CHANGES FROM BASE PRODUCT VEV- L4025 (1554) TO AC-069-90 (5528)

Assembly PI Approval J GREEN	Approved by D WALLIN		Checked by W SINDEN		Drawn by I DEASY
Angle of Projection  Third Angle	Units mm	Scale N/A	Released 24/08/2018	Assembly Ref AC-069-90	
	Part No 5528		BE-003771-0-18

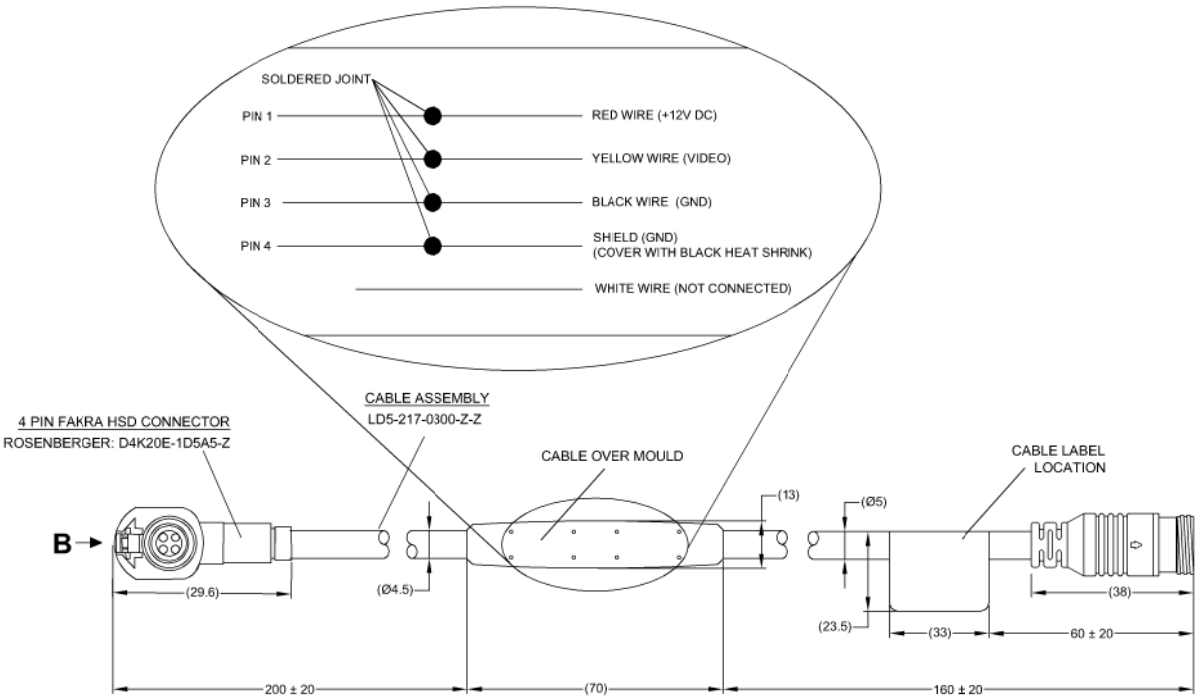
- CHANGE:
- 1. REPLACE 4 PIN FEMALE VBV CONNECTOR WITH OVER MOULDED CABLE ASSEMBLY
 - 2. VBVL4025 CB-LBL TO BE REPLACED BY AC-069-90 (5528) CB-LBL
 - 3. VBV L4025 GB-LBL REPLACED BY AC-069-90 (5528) GB-LBL
 - 4. AC-069-IG (5322) ADDED
